**SAN ANTONIO WATER SYSTEM**  
**CHILLED WATER PLANT IMPROVEMENTS PROJECT**

**SAWS JOB NUMBER 15-7502**

**ADDENDUM NO. 2**  
**December 17, 2015**

**CHILLED WATER  
PLANT IMPROVEMENTS  
IRRIGATION PLAN**

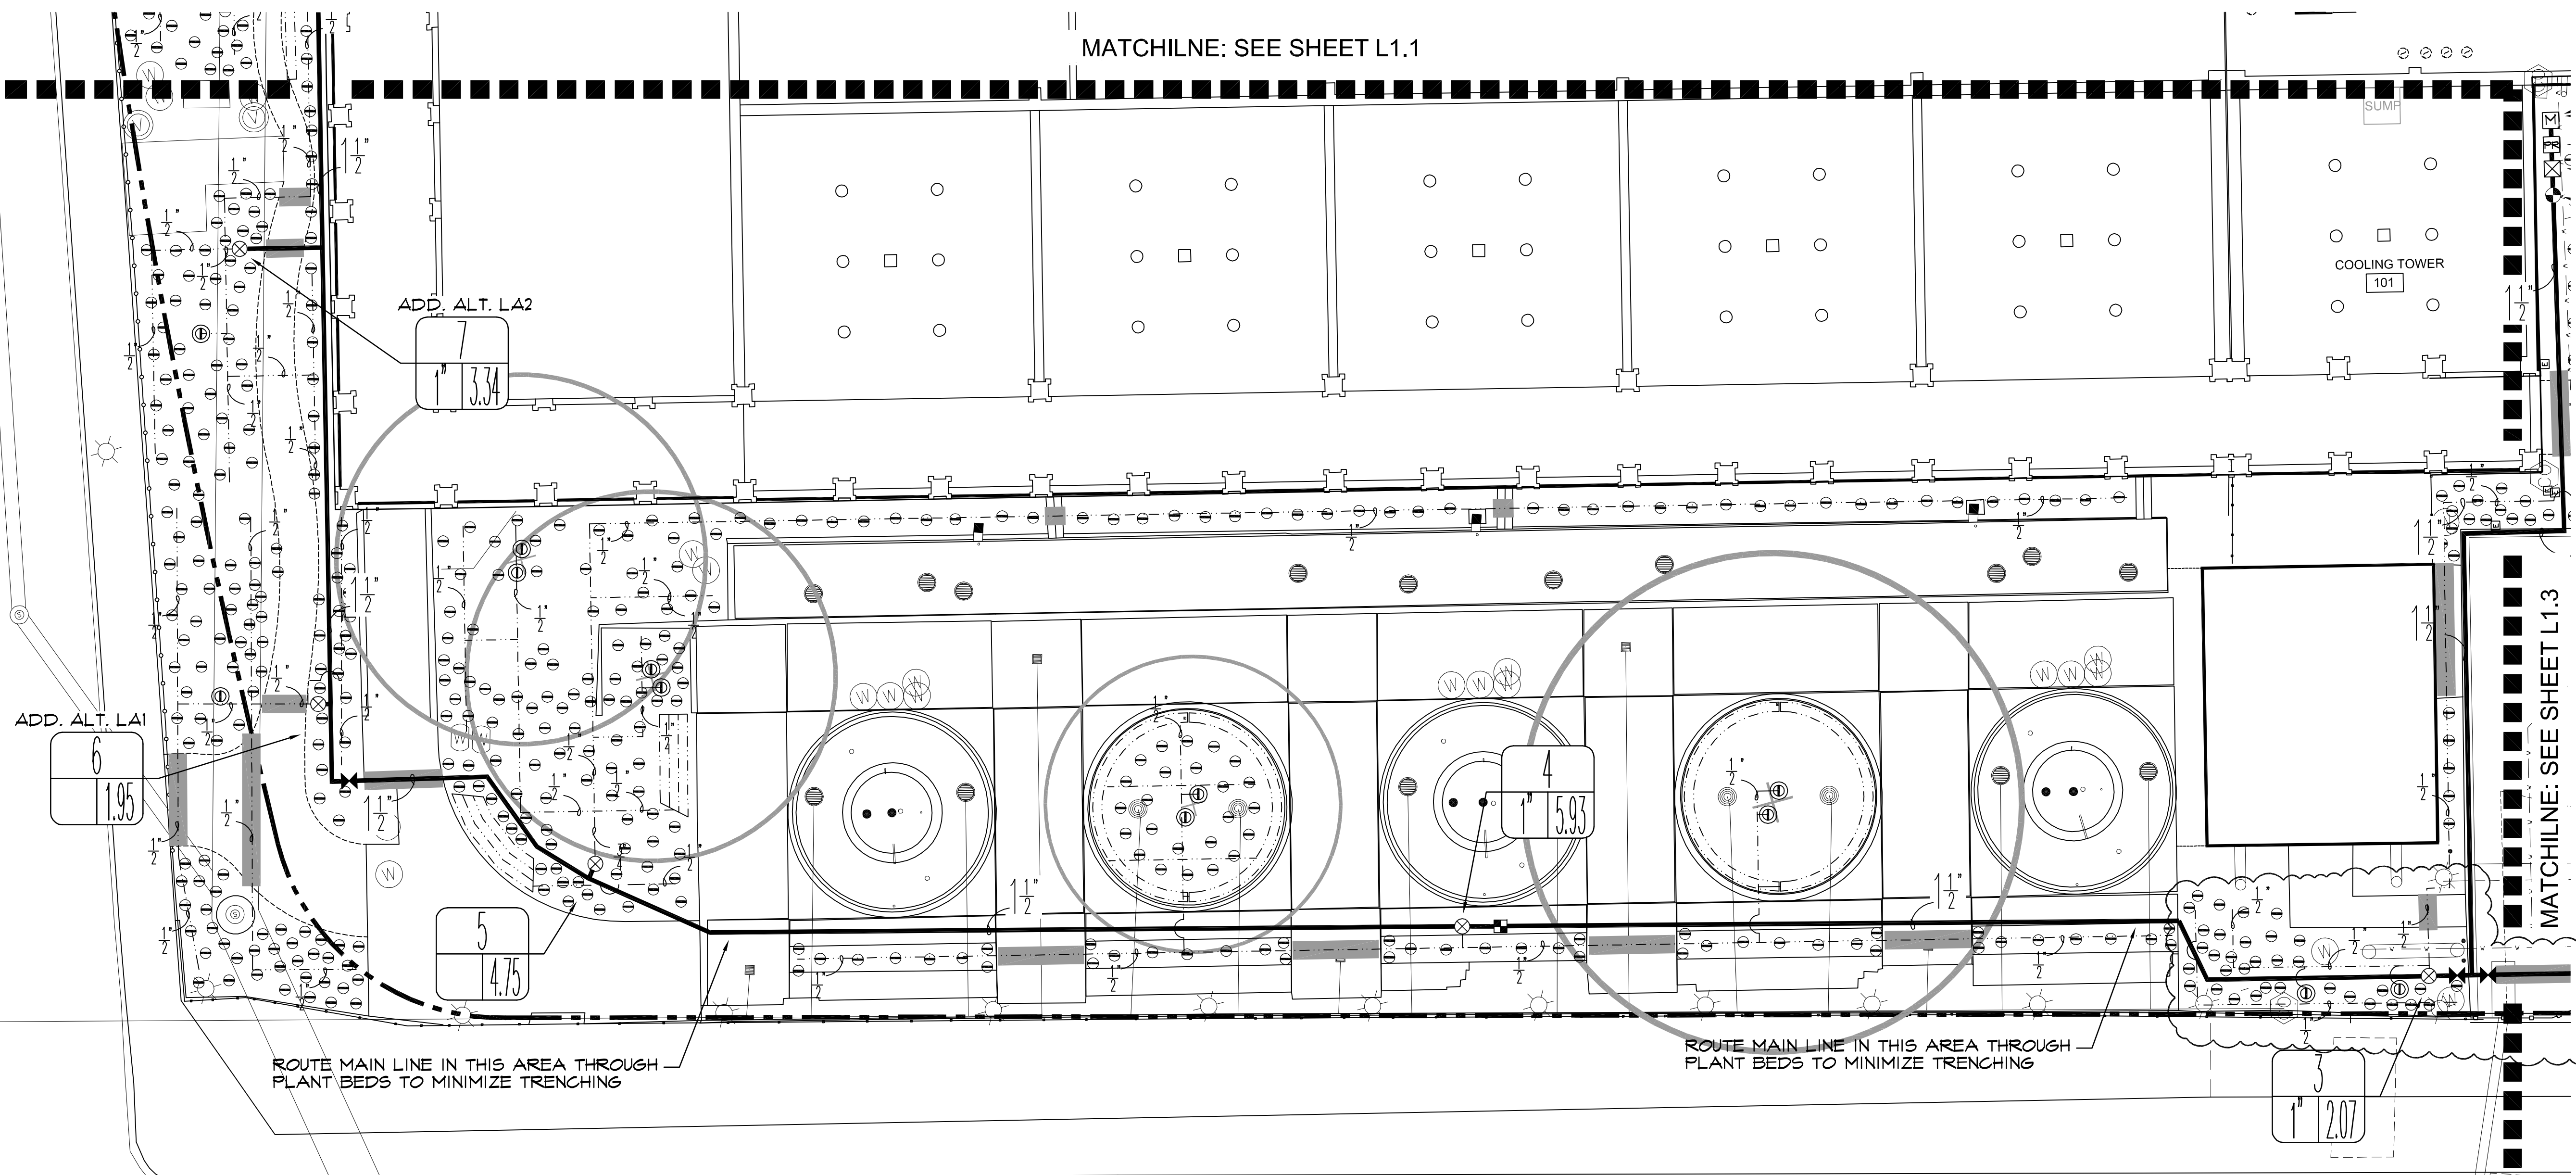
ROUTE MAIN LINE IN THIS AREA THROUGH PLANT BEDS TO MINIMIZE TRENCHING

ROUTE MAIN LINE IN THIS AREA THROUGH PLANT BEDS TO MINIMIZE TRENCHING

**CHILLED WATER  
PLANT IMPROVEMENTS  
IRRIGATION PLAN**

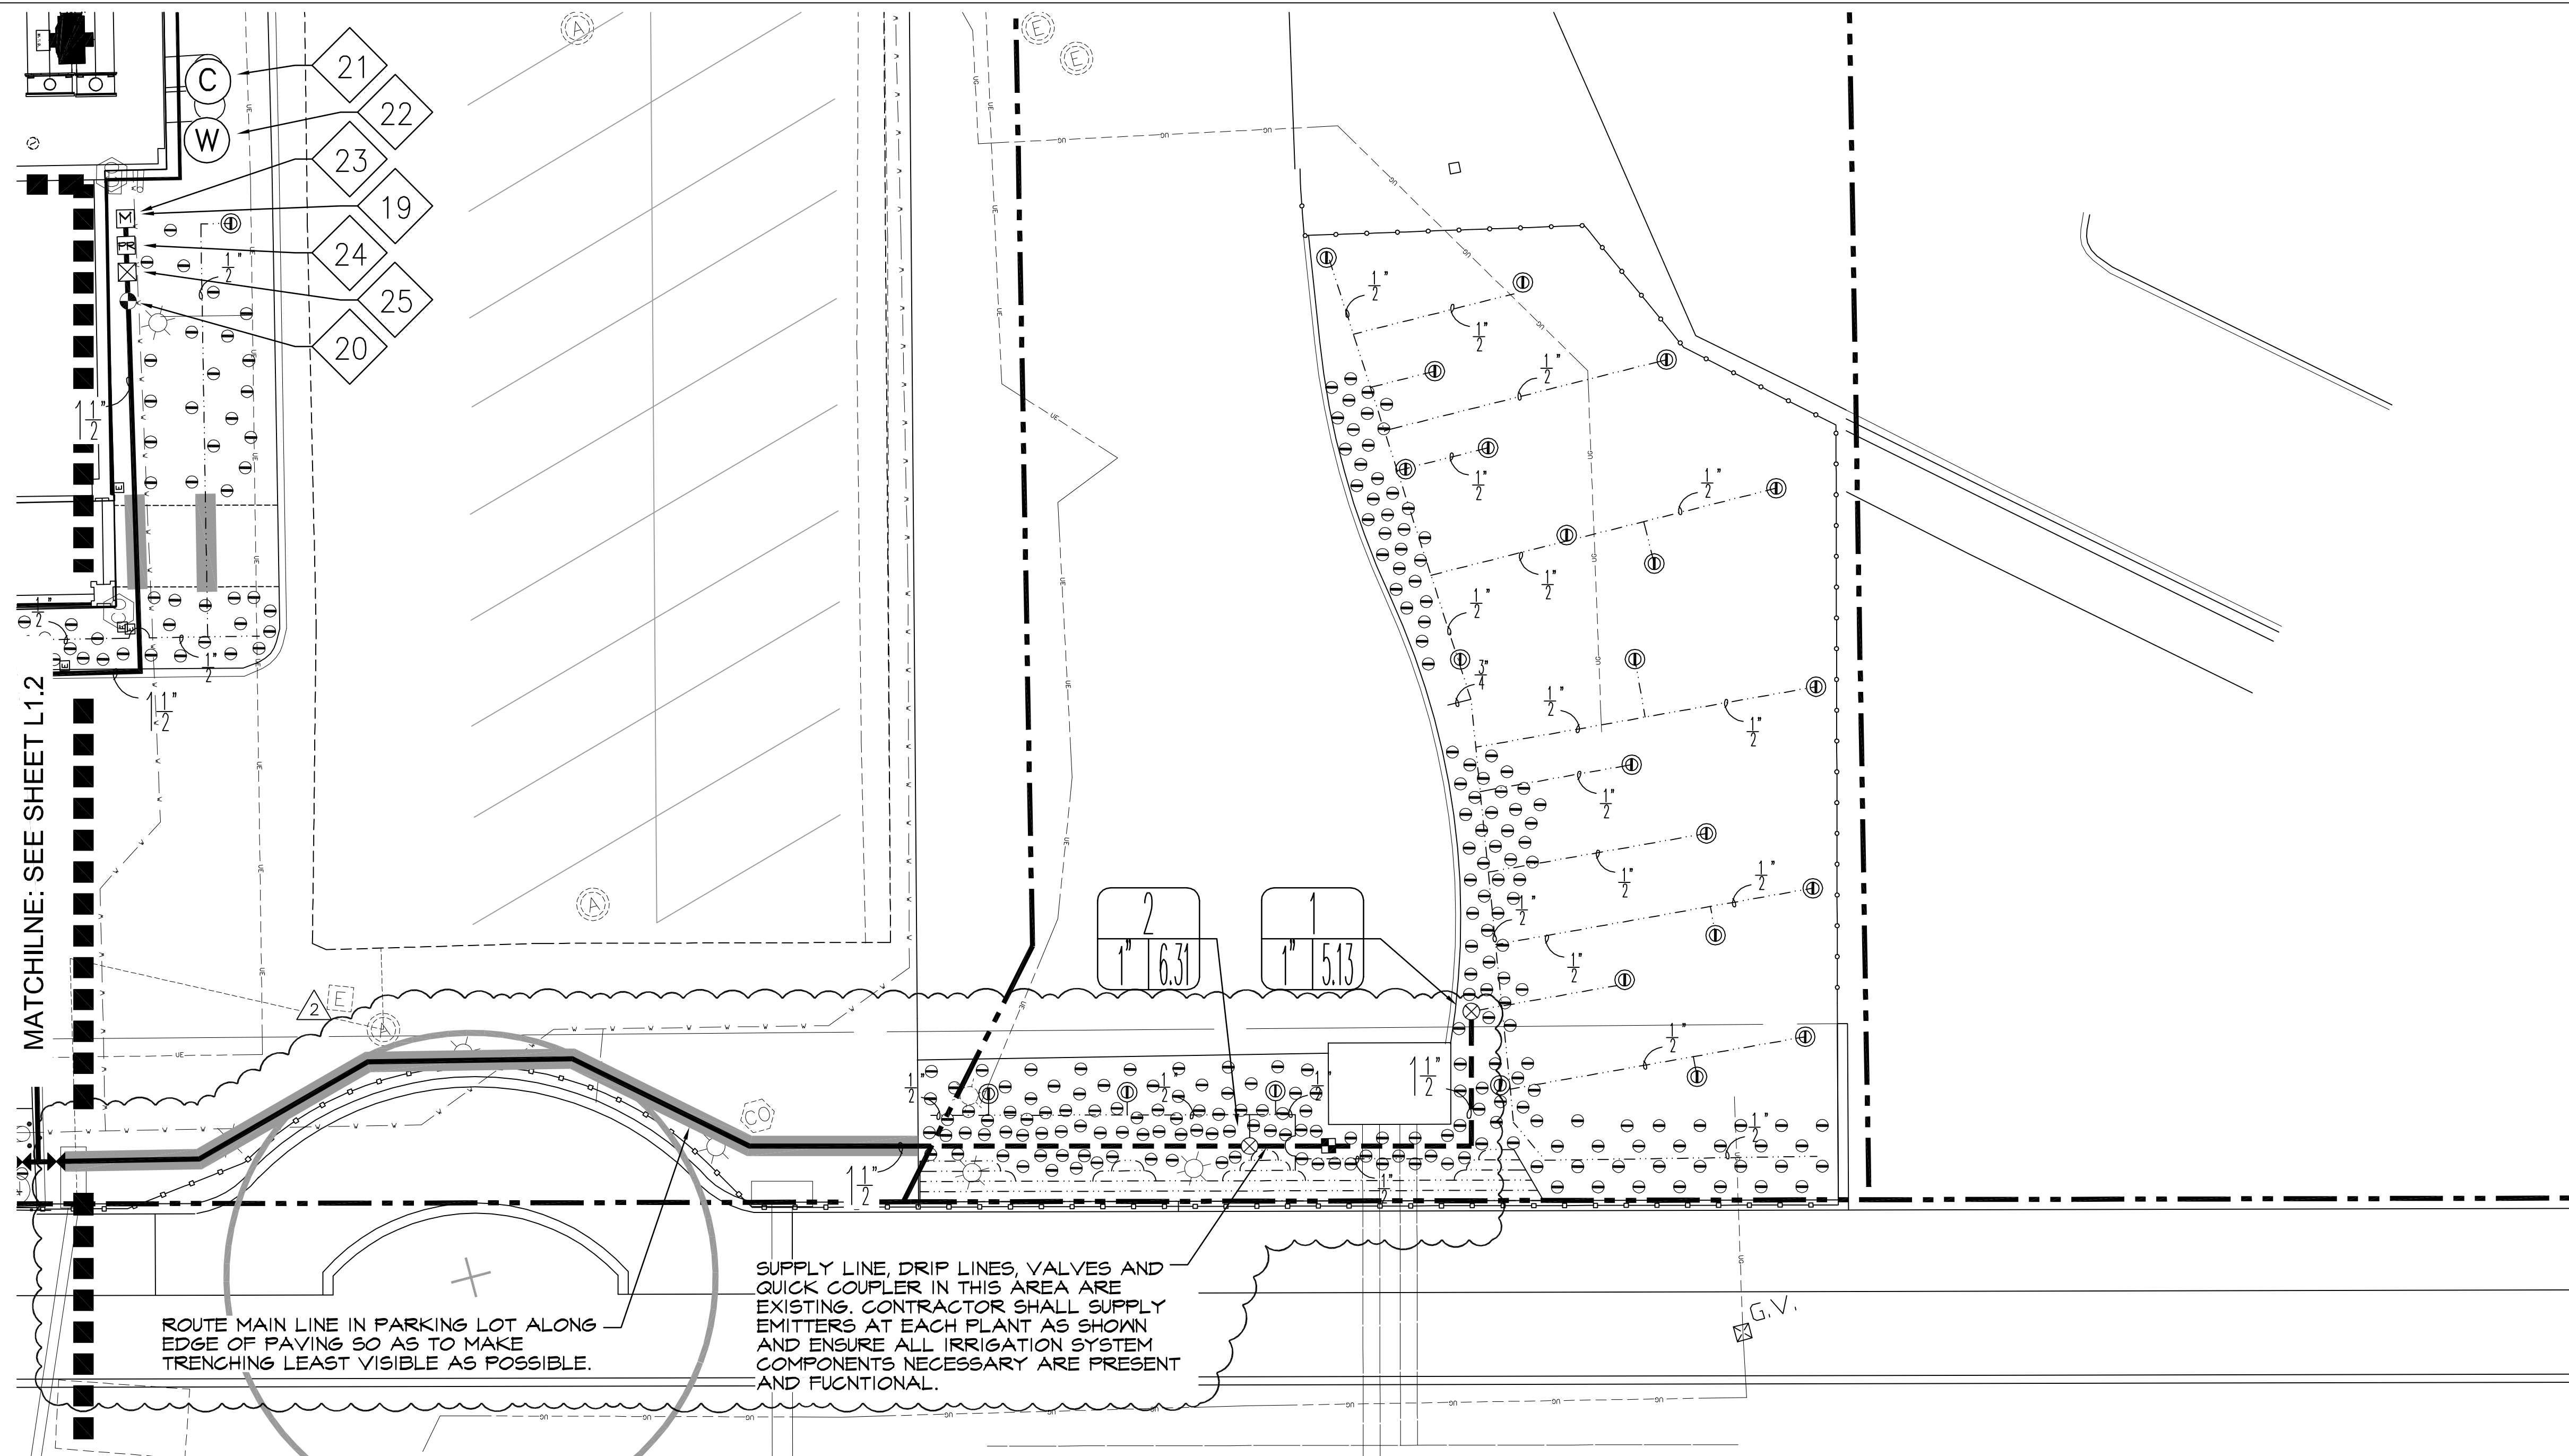
- Item 1: Add 120V, 20A Circuit #'L2-8' for power to Rainbird Controller (irrigation controls).  
See Drawing Sheet L1.3 for location of Rainbird Controller.
